# Community Planning & Permitting

### MEMO

**RE:** Referral Response, Docket SI-22-0002, CO 119 Safety and Mobility and Bikeway Projects: Areas and Activities of State Interest (1041) review for combined projects along Colorado Highway 119 (CO 119) related to safety and mobility improvements and construction of a bikeway from approximately 47th Street/Foothills Parkway in the City of Boulder to milepost 54.2 in the City of Longmont.

TO: Pete L'Orange, Planner II; Community Planning & Permitting, Development Review Team - Zoning

Project No./Code	
Sheet Number	159

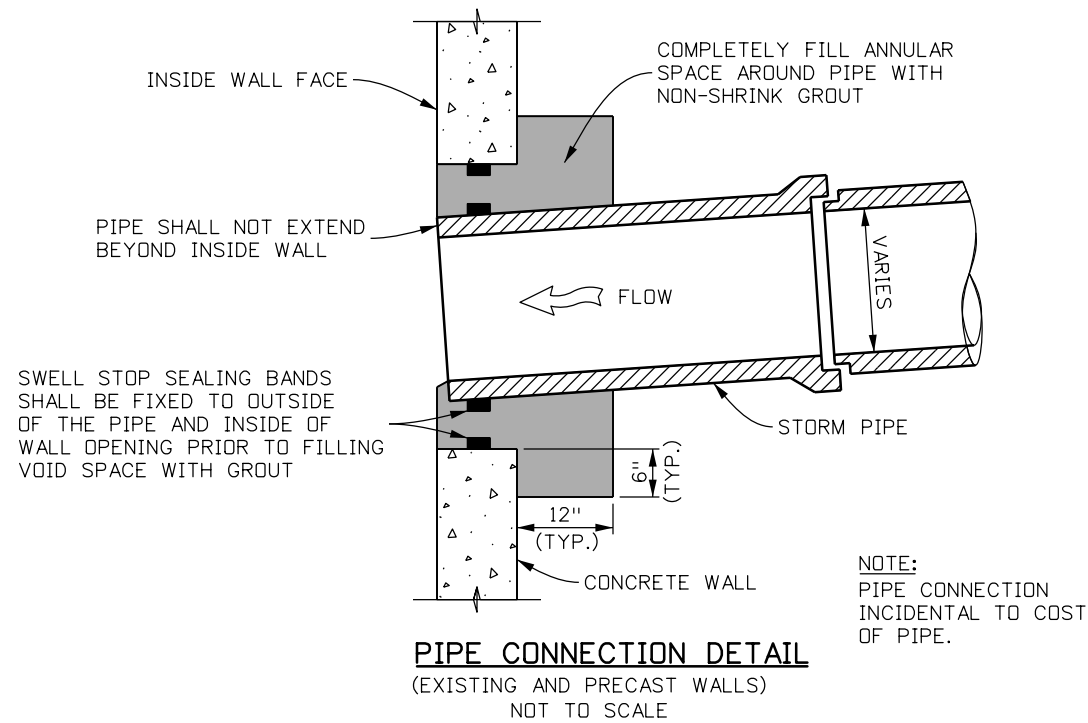
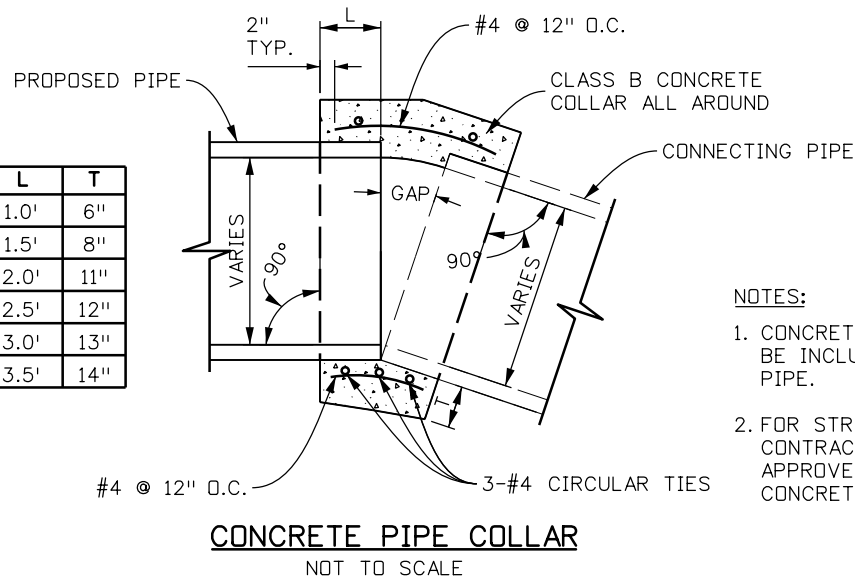
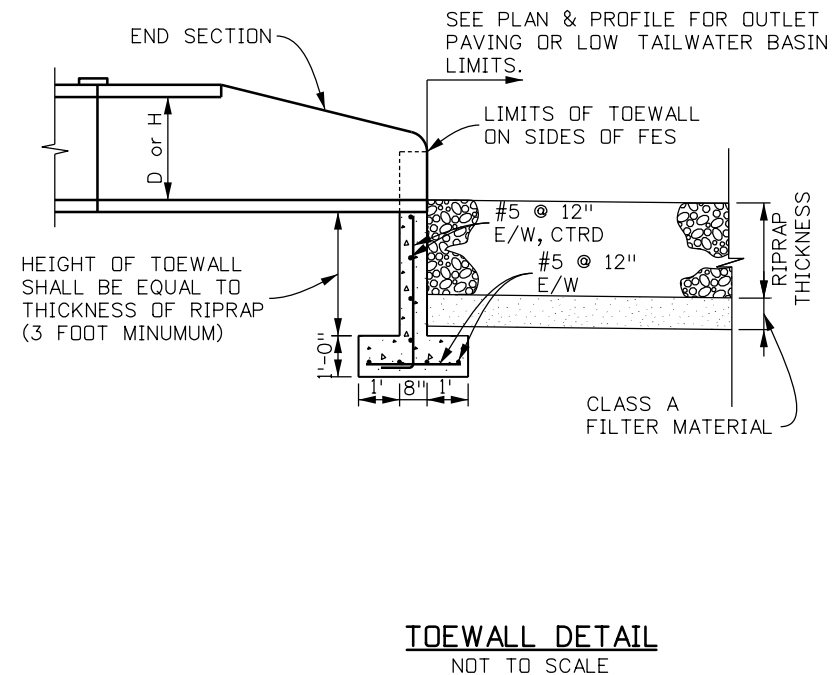
See comments in preliminary drainage report and included plan sheets related to FSD ponds

Project No./Code  
 Sheet Number 160

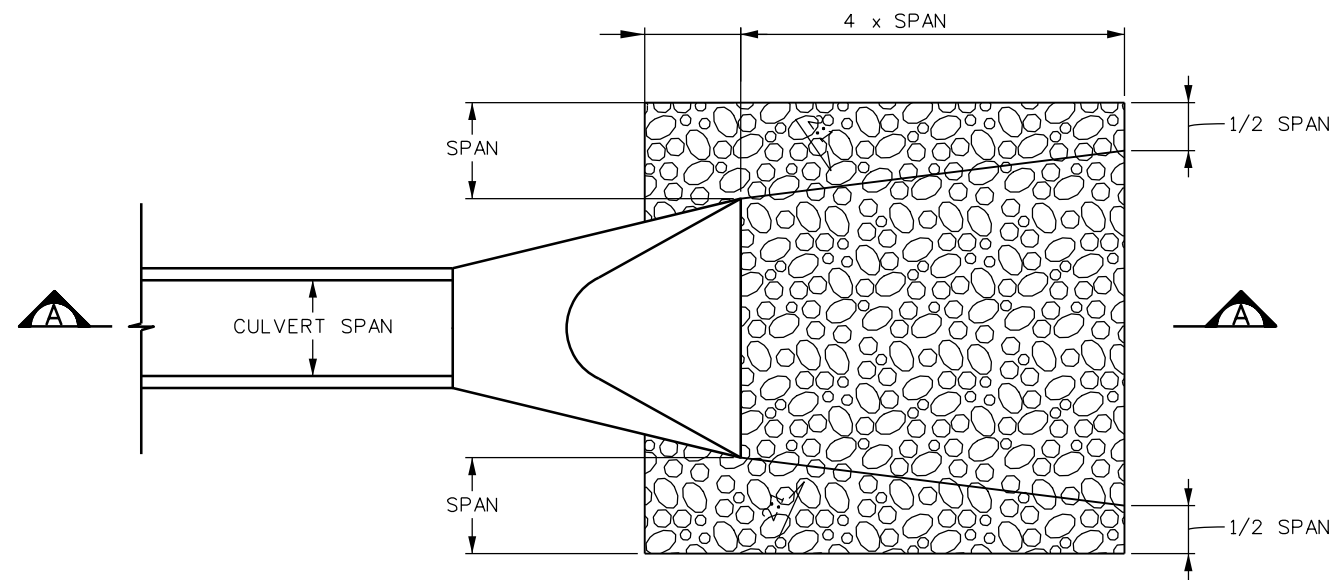
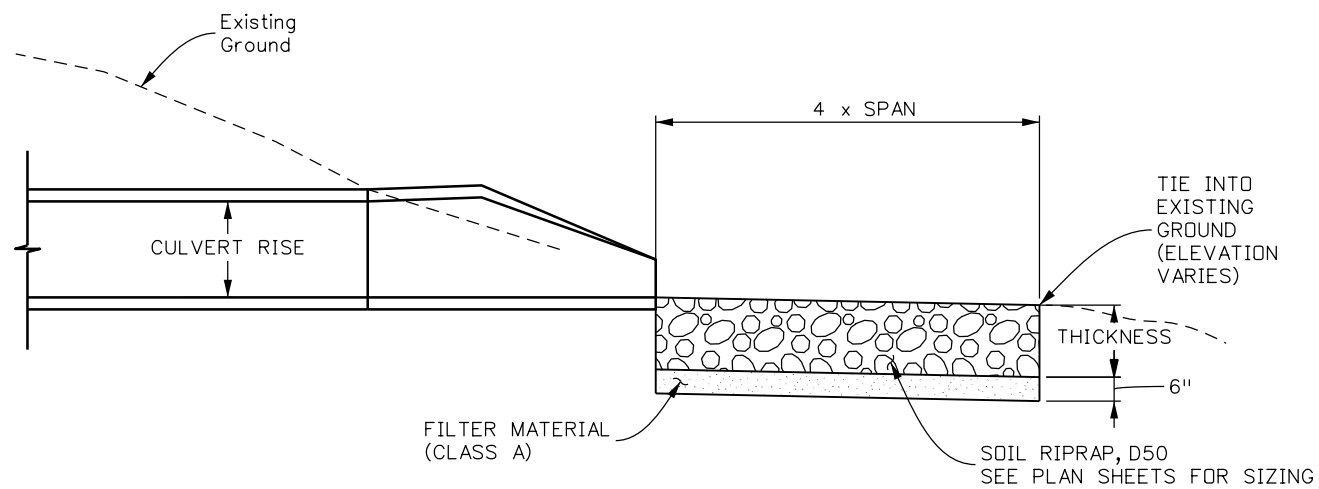
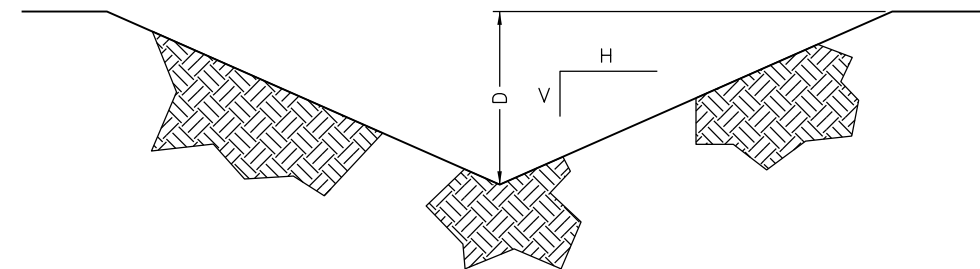
1. For FSD ponds, forebays are needed for all concentrated inflows. Please provide design information for forebays or equivalent measures such as a hydrodynamic separator in next design submittal.
2. It is unclear if micropools will be provided based on drawings. If alternative approach is used to keep small orifices from clogging, please describe and justify approach.
3. Design of initial surcharge volume (ISV) and trickle channel needed in next submittal.
4. Need to show spillways and emergency overflow paths in next design submittal, including freeboard along emergency overflow path in the event that the outlet becomes plugged. Spillways should be designed for fully developed pond inflows.

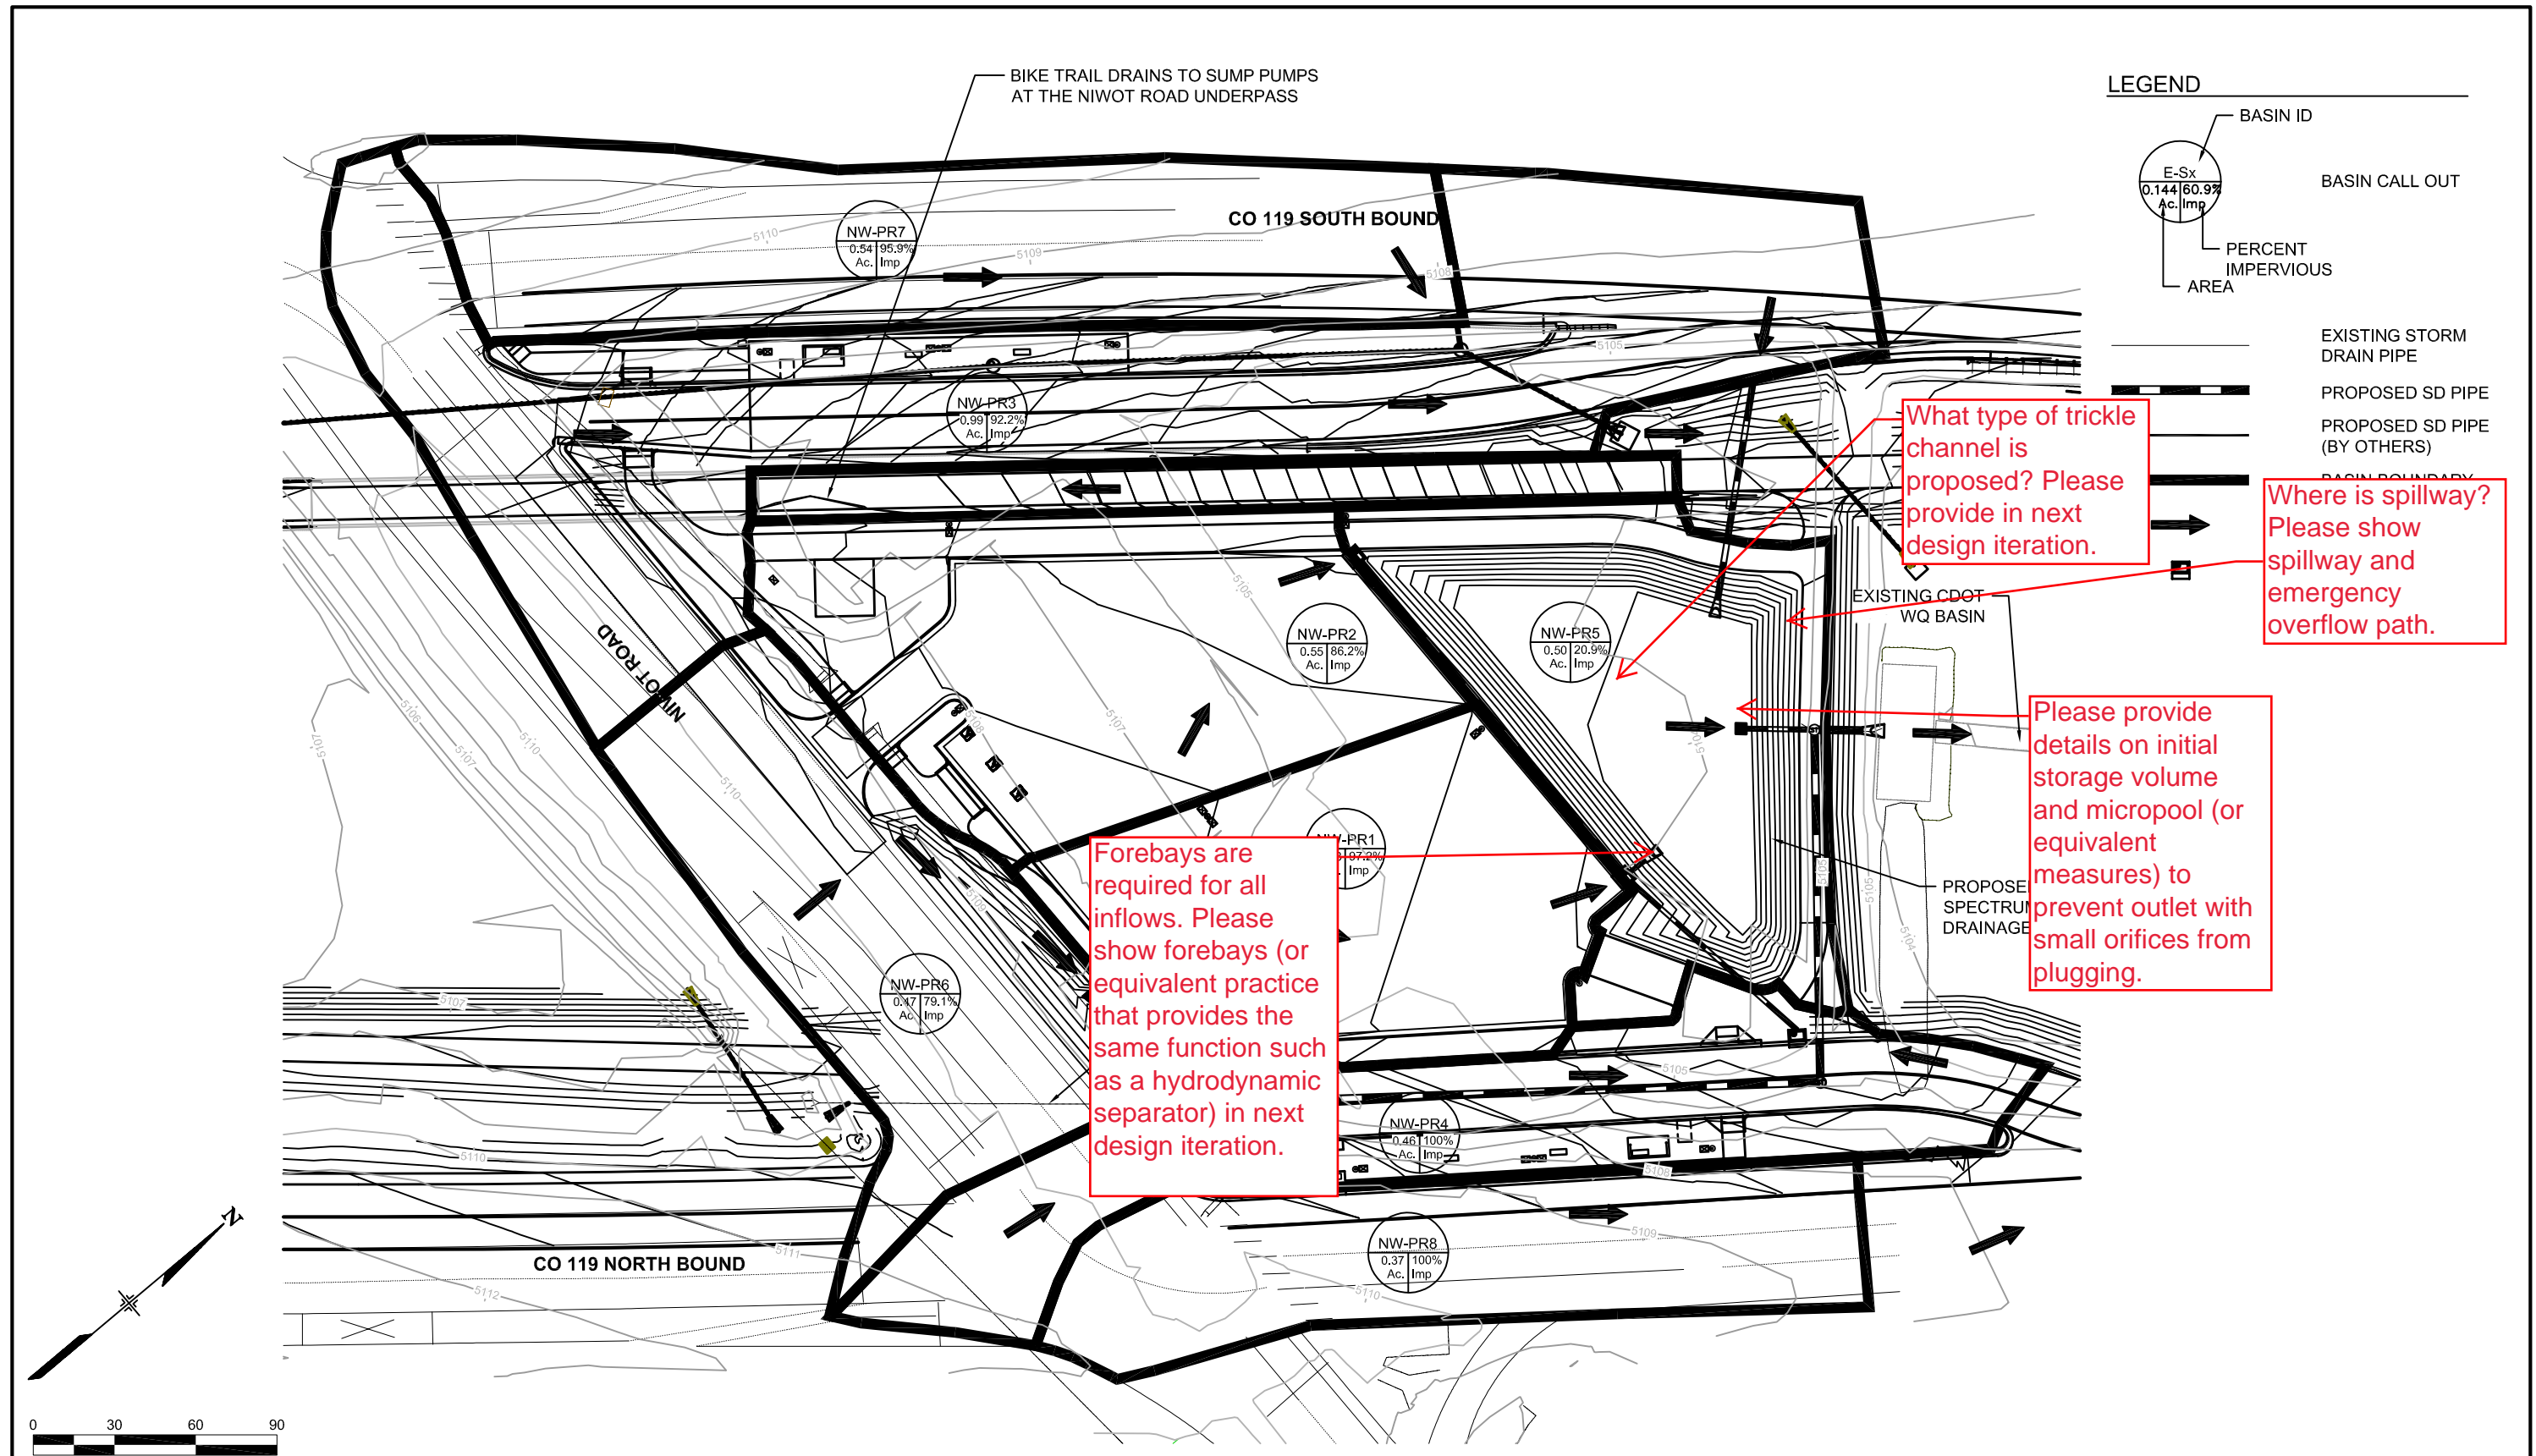
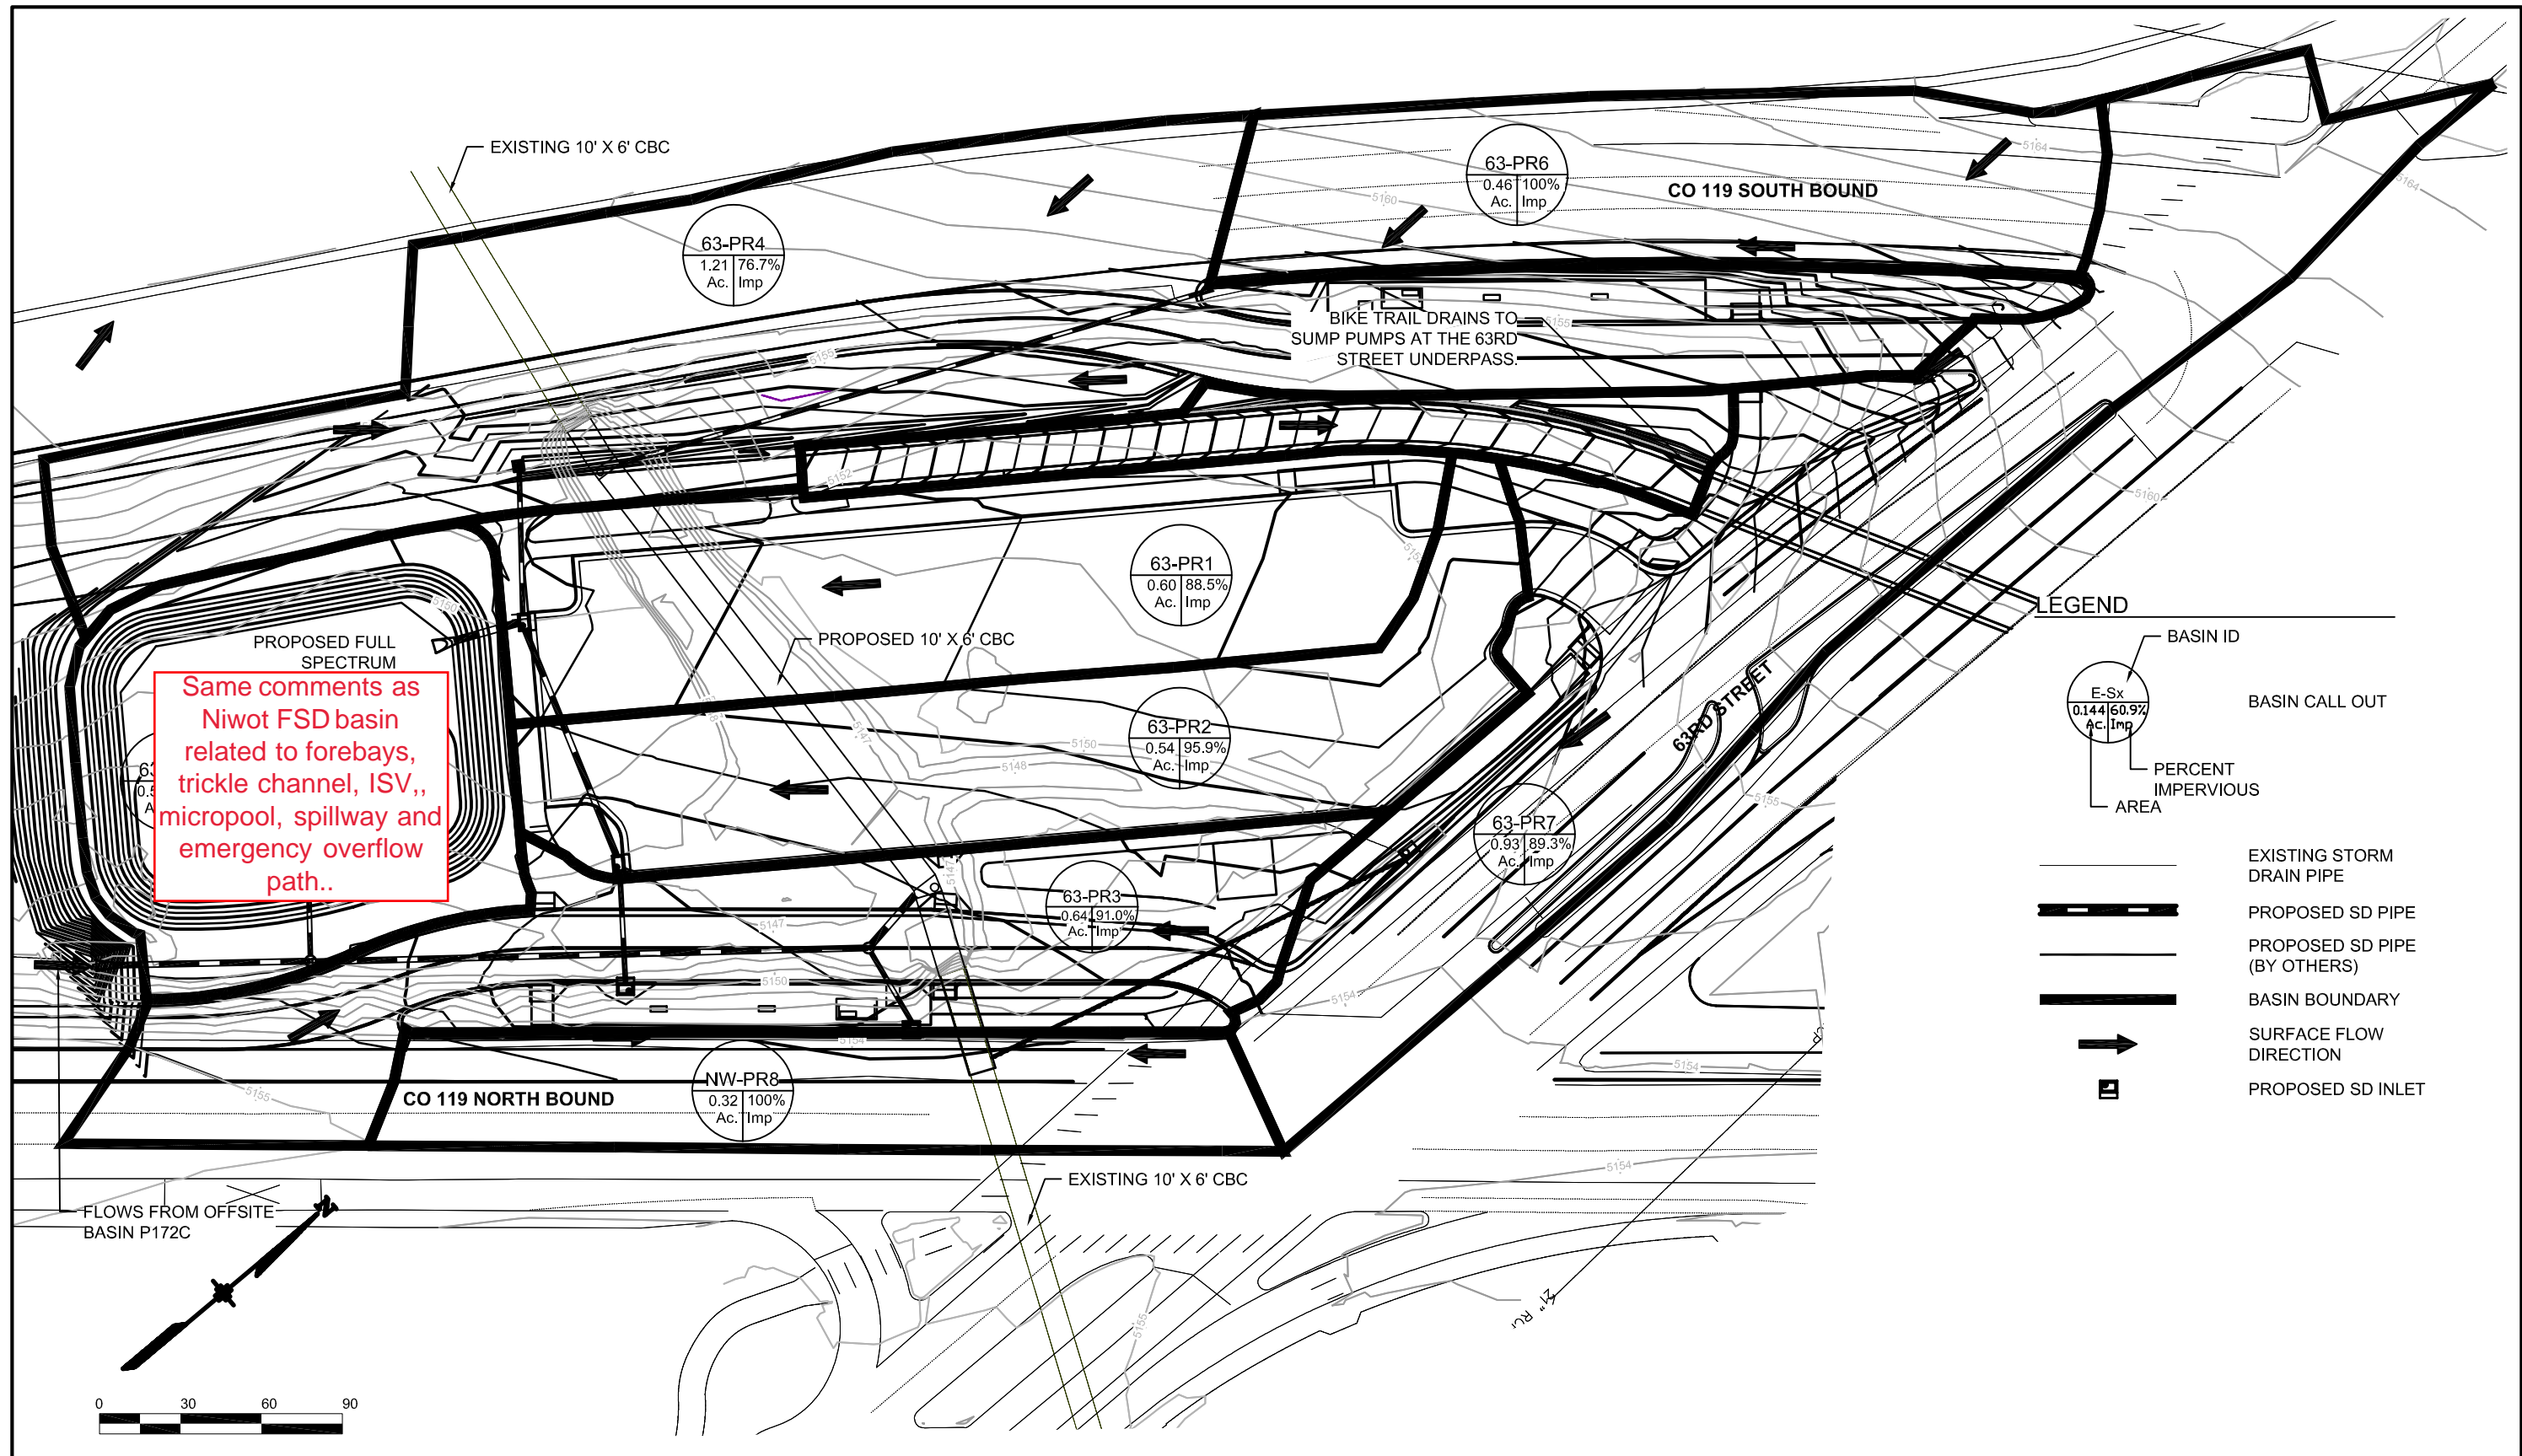
Same comment on small orifices.
